**Written submission from  
Northwatch**

**Regulatory Oversight Report for Uranium  
and Nuclear Substance Processing Facilities  
in Canada: 2017**

Re. **Northwatch Comments on Regulatory Oversight Report on Uranium Processing and Nuclear Processing Facilities in Canada: 2017**

*Soil and Tree Foliage Survey in the Vicinity of Cameco’s Blind River Refinery, Blind River, Ontario (2012)” 2012 Report, MOE*

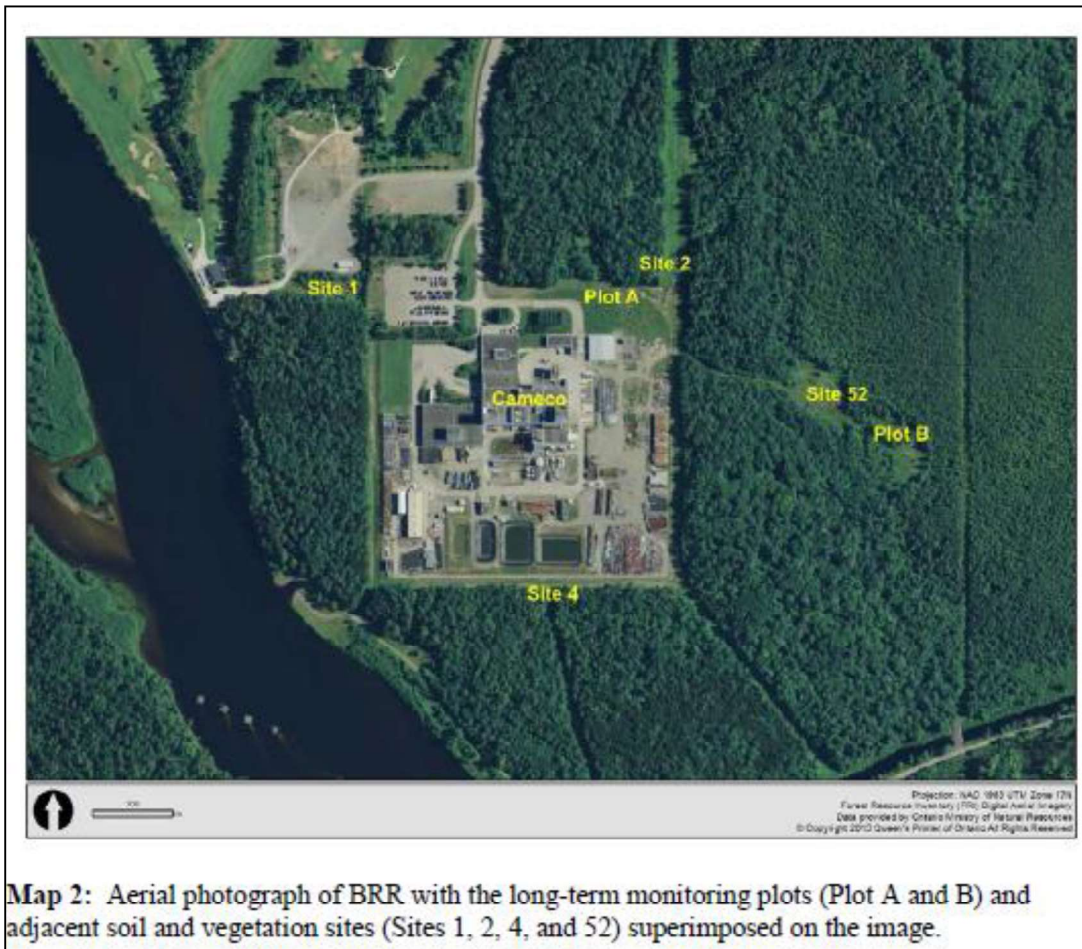
As with the Ministry’s 2007 report and Northwatch’s 2011 report, in the Ministry of the Environment’s 2012 report a small number of the sampling sites showed increased concentrations; others remained relatively constant and a few showed decreases.

The MOE 2012 report indicated that the highest soil uranium concentrations in 2012 were reported at sites within 500 m of BRR (Sites 4, 2, 1, 52, and 8), consistent with MOE soil uranium data since 2000. As in the Northwatch 2011 report, Sites 2 and 4 results show the highest concentration of uranium, and MOE noted that in 2012 soil uranium concentrations were much higher at Site 2 than in previous years.

We note that Site 4 was one of two sites showing the highest concentration of uranium in the soil, and it is located immediately south of the perimeter fence. Site 1 was one of five sites showing the highest concentrations and it is located west of perimeter fence. Cameco indicated in their 2016 Compliance report that “As a result of a third-party review of Cameco soil monitoring locations, in conjunction with construction of a berm outside the refinery perimeter fence line, three new soil sampling locations were
